12th April 2022

The General Manager
Northern Beaches Council
PO Box 82
Manly NSW 1655

Development Application No. DA2021/2262
Issues response/ Supplementary Statement of Environmental Effects
Demolition works and construction of a dwelling house including garage
and swimming pool
14 Ocean Road, Palm Beach

Figure 1 - Plan extract DA10(E) showing the minor building elements breaching the 8.5 metre building height standard

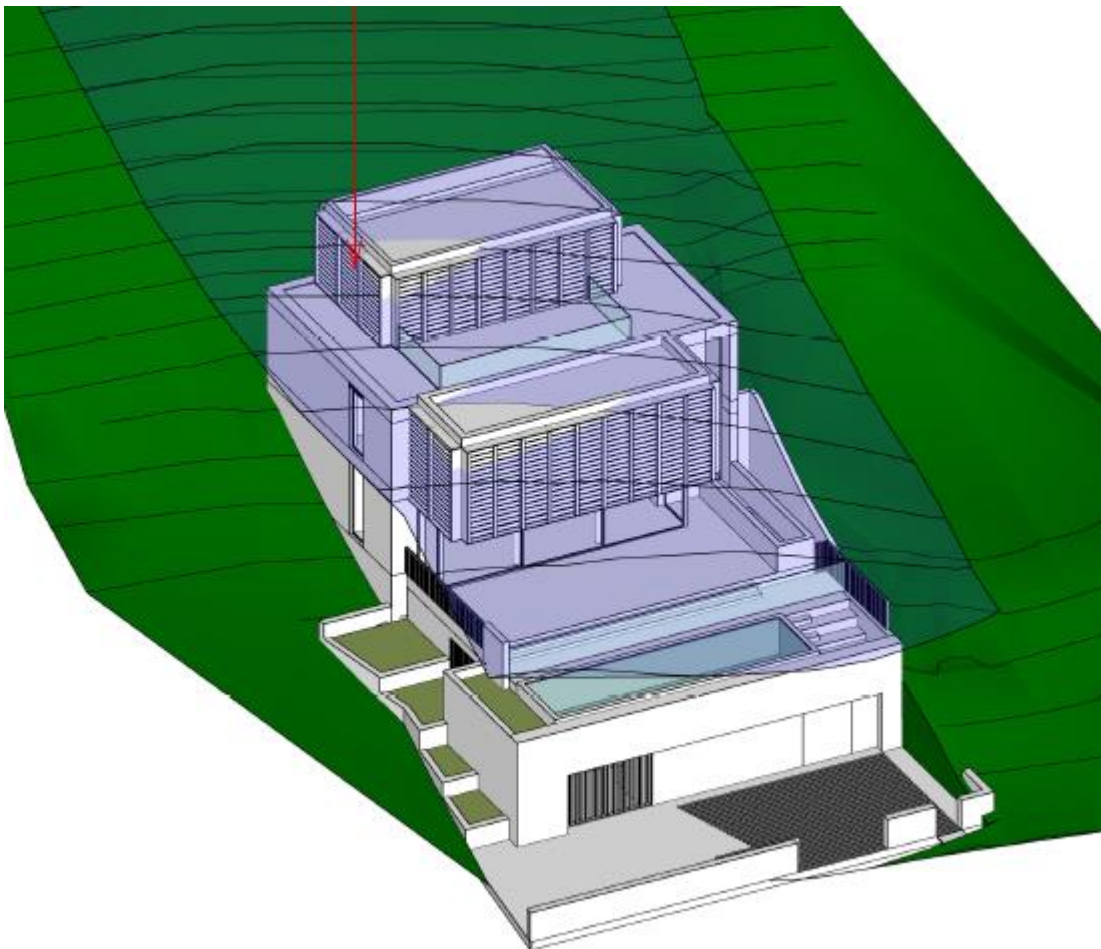
Clause 4.3 Height of Buildings

Response: As you are aware, the natural ground levels of the land have been artificially modified to accommodate the pre-existing dwelling house. In this regard, this submission is accompanied by an amended contour diagram (DA14(E)) which interpolates the natural undisturbed ground levels across the site. The amended roof plan DA06(I) nominates the natural ground levels below the southern edges of the proposed upper-level roof form with the south-eastern corner of the Level 2 ensuite having a maximum parapet height of RL 19.71 located immediately above interpolated natural ground level of RL 10.00. This confirms a maximum building height of 9.71 metres which is below the 10 metre concessional standard which may be considered on steeply sloping sites.

We note that the areas of the development which exceed the 8.5 metre height standard have been significantly reduced through a reduction in overall building height achieved through the provision of increased setbacks to the southern boundary at each level and a pulling back of the upper level of the development relative to the street. We are satisfied that that both quantitatively and qualitatively the breaching building height elements are appropriately described as minor with the breaching elements depicted on the plan extract DA10(E) at Figure 1 over page.

The proposal is however compliant with 10 metre concessional building height for steeply sloping sites which reflects the appropriate scale of the dwelling and will ensure that the building sits down below the level of surrounding tree canopy. The development strikes a balance between keeping the building low into the site to reduce its visual prominence and excavation with the resultant stepped 2 storey building form and height ensuring the development will sit below the height of surrounding tree canopy level.

In relation to an assessment against the considerations at clause 4.3(2D) of PLEP 2014 we rely on the assessment contained within the original Statement of Environmental Effects to demonstrate that the height of the building is acceptable have regard to its site-specific design response to the topographical characteristics of the site and the proposals juxtaposition with surrounding development. Under such circumstances, a clause 4.6 variation request is not required to support the building height proposed.

Figure 2 - Plan extract DA30(A) demonstrating the maintenance of views available from No. 12 Sunrise Road

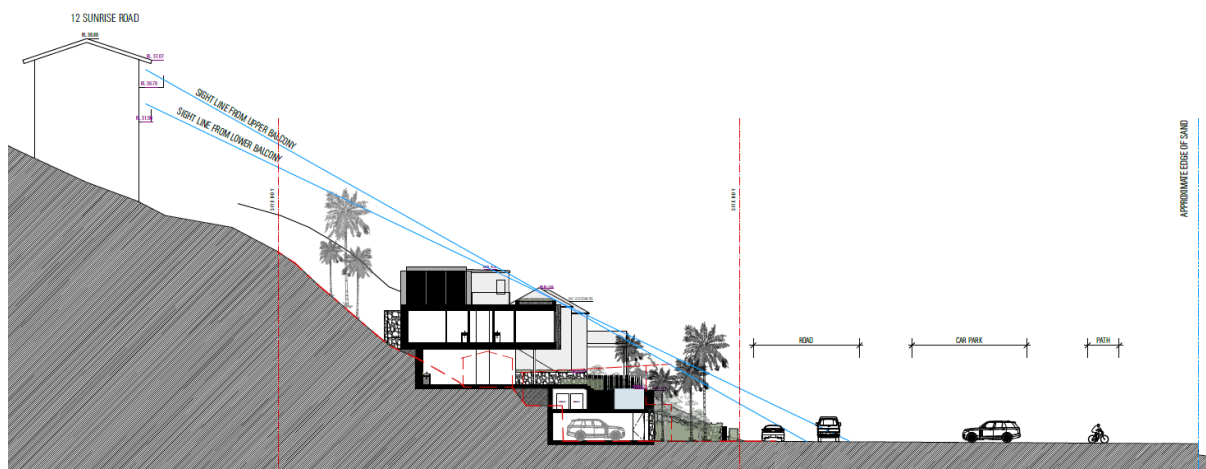
Clause C1.3 View Sharing

Response: We note that concerns have been raised from the owner of No. 12 Sunrise Road that the proposed development may obstruct views currently available across the subject property towards Palm Beach and its immediate environs. This submission is accompanied by view analysis plan DA30(A), which has been prepared by the project Architect from available survey information, which demonstrates that the proposed development will not obstruct scenic views available from No. 12 Sunrise Road. An extract of this plan is at Figure 2 below.

In relation to the view loss concerns expressed by the owner of No. 13 Ocean Road it is clearly evident from an inspection of subject site that the proposed development will not impact on any scenic views currently available from the principle living and private open space areas of this adjoining property.

Given the ability to undertake an accurate assessment as to potential view impacts from an inspection of the site and the view analysis diagram DA30(A) we consider it unreasonable to insist upon the erection of survey accurate height poles in this particular instance.

Figure 3 - Plan extract DA12(E) demonstrating the extent of building envelope breaching elements

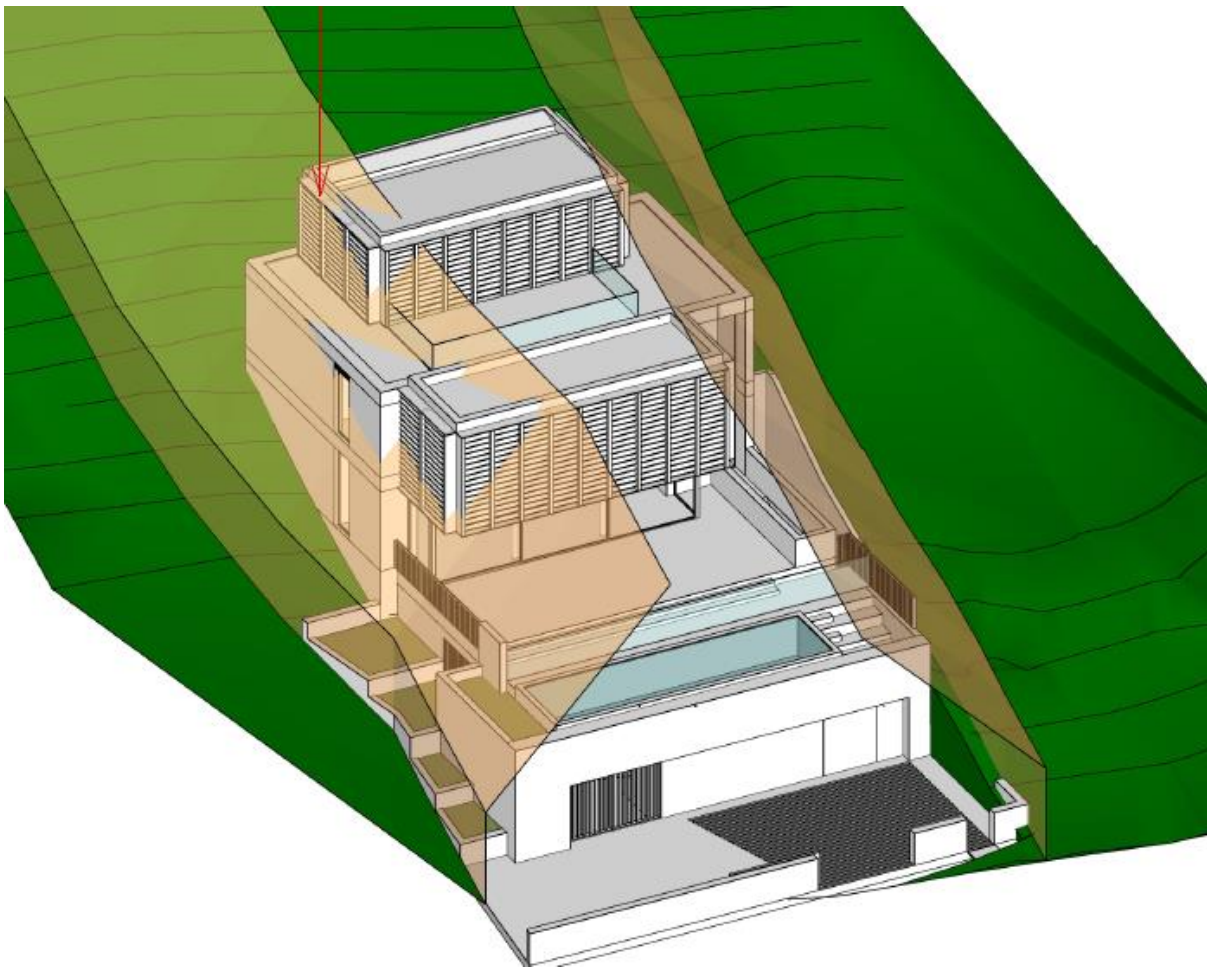
Clause D12.8 Building Envelopes

Response: As previously indicated, the accompanying plans provide for increased setbacks at each level to the southern boundary of the property and a significant reduction in the building envelope breach. The extent of remaining building envelope breach is depicted in Figure 3 below.

This plan demonstrates that the extent of building envelope breach has been reduced to the extent necessary to ensure consistency with the objectives of the control namely:

- The breaching elements are confined to relatively small areas of building façade and result from a combination of the irregular southern boundary alignment and the topography of the site.

- The breaching elements do not prevent the development from achieving the desired future character of the Palm Beach locality as previously outlined.
- Notwithstanding the breaching elements, the development responds to, reinforces and sensitively relates to spatial characteristics of the existing natural environment.

- Notwithstanding the breach element, the highly articulated and modulated building façades minimise the bulk and scale of development.
- The breaching elements do not give rise to any public or private view affectation.

- The breaching elements do not give rise to any adverse privacy, amenity or unacceptable solar access implications.
- The breaching elements do not compromise the landscape quality of the development.

Given the developments ability to satisfy the objectives of the building envelope control, notwithstanding the minor building envelope breaches proposed, strict compliance has been found to be both unreasonable and unnecessary under the circumstances.
